RE: **Dunkin' Donuts**
4208 Central SW
Grading Plan Stamp Date: 7/26/19
Hydrology File: K12D015D

Based on the submittal received on 9/10/19, this project is approved for Building Permit.

Grading Plan

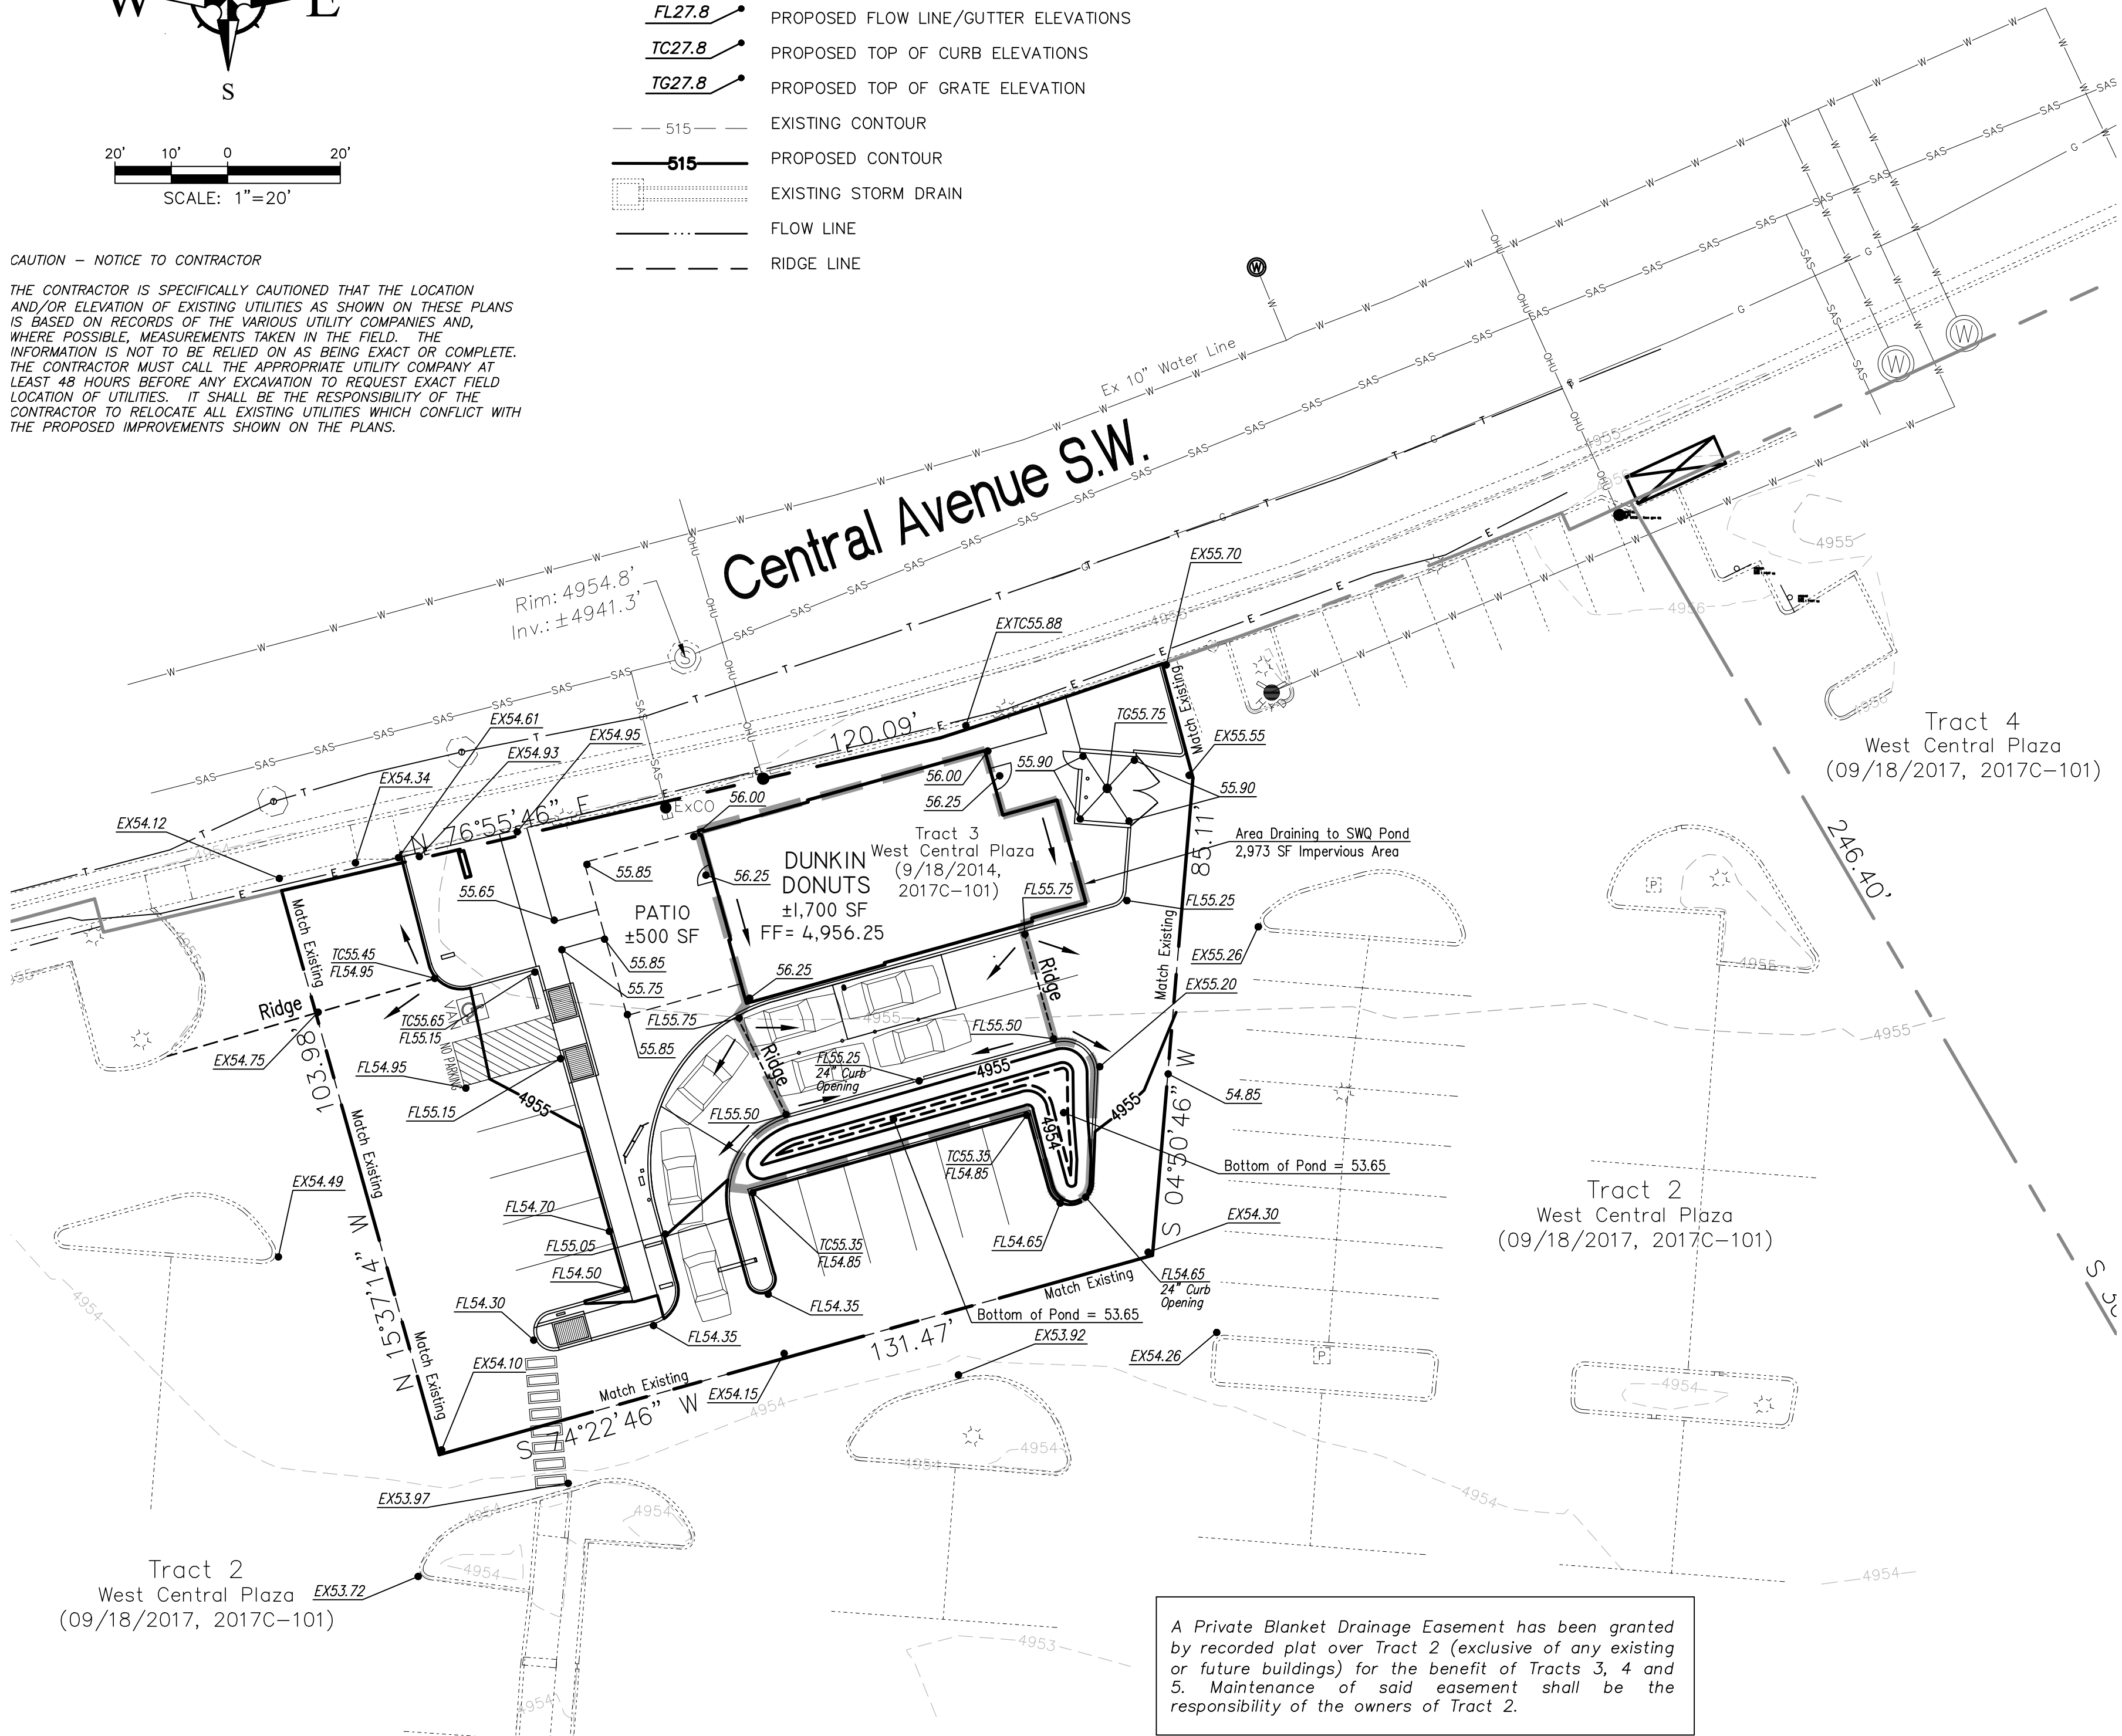
1. Engineer's Certification, per the DPM Chapter 22.7: *Engineer's Certification Checklist For Non-Subdivision is required.*

2. A Bernalillo County Recorded Private Facility Drainage Covenant is required for the stormwater quality pond. The original notarized form, exhibit A (legible on 8.5x11 paper), and recording fee (\$25, payable to Bernalillo County) must be turned into DRC (4th, Plaza del Sol) for routing. Please contact Charlotte LaBadie (clabadie@cabq.gov, 924-3996) regarding the routing and recording process for covenants. The routing and recording process for covenants can take a month or longer; Hydrology recommends beginning this process as soon as possible as to not delay approval for certificate of occupancy.
